Access Compliance Report

Public Rights-of-Way

(Curb Ramps)

Intersection ID: 28976	Main Street: BANNINGTON_RD	Cross Street: CARMEL_COMMONS_BV	Location: SE
ADA ID: 0701EFF3348D	Ramp Type: PerpDiag	Initial Pass/Fail: Fail	Overall Compliance: No
Codes/Mitigation Info/Possible Solution		Field Measurements/Component Compliance

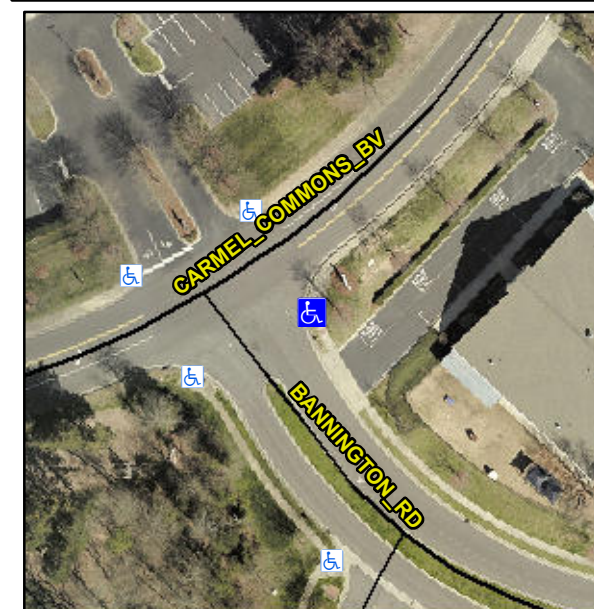
Not Found, R304.5.1, R304.5.3

Compliance	Description	Data	Compliance	Description	Data
N/A	Ramp Length (in)	95.0	Yes	Ramp Slope (%)	7.4
No	Ramp Width (in)	45.0	No	Ramp XSlope (%)	4.4
N/A	Flare Type LT	N/A	N/A	Flare Type RT	N/A
N/A	Flare Slope LT (%)	N/A	N/A	Flare Slope RT (%)	N/A
N/A	Flare Traversable LT?	N/A	N/A	Flare Traversable RT?	N/A
N/A	Landing Length (in)	N/A	N/A	DWS Provided?	N/A
N/A	Landing Width (in)	N/A	N/A	DWS Contrast?	N/A
N/A	Landing Slope (%)	N/A	N/A	DWS Length (in)	N/A
N/A	Landing X Slope (%)	N/A	N/A	DWS Full Width?	N/A
N/A	Landing Curb? (Y/N)	N/A	N/A	DWS Offset (in)	N/A
N/A	Shared Landing?	N/A			
N/A	Gutter Ponding?	N/A	N/A	Gutter Slope (%)	N/A
N/A	Gutter Lip Ht (in)	N/A	N/A	Gutter X Slope (%)	N/A
N/A	Painted X Walk1?	No	N/A	Painted X Walk2?	No
	X Walk 1 Direction	To N		X Walk 2 Direction	To W
N/A	X Walk 1 Width (in)	N/A	N/A	X Walk 2 Width (in)	N/A
	X Walk 1 Slope (%)	0.3		X Walk 2 Slope (%)	3.9
	X Walk 1 X Slope (%)	4.5		X Walk 2 X Slope (%)	3.9

Remove & Replace Curb Ramp With Two New Directional Ramps or Equivalent.
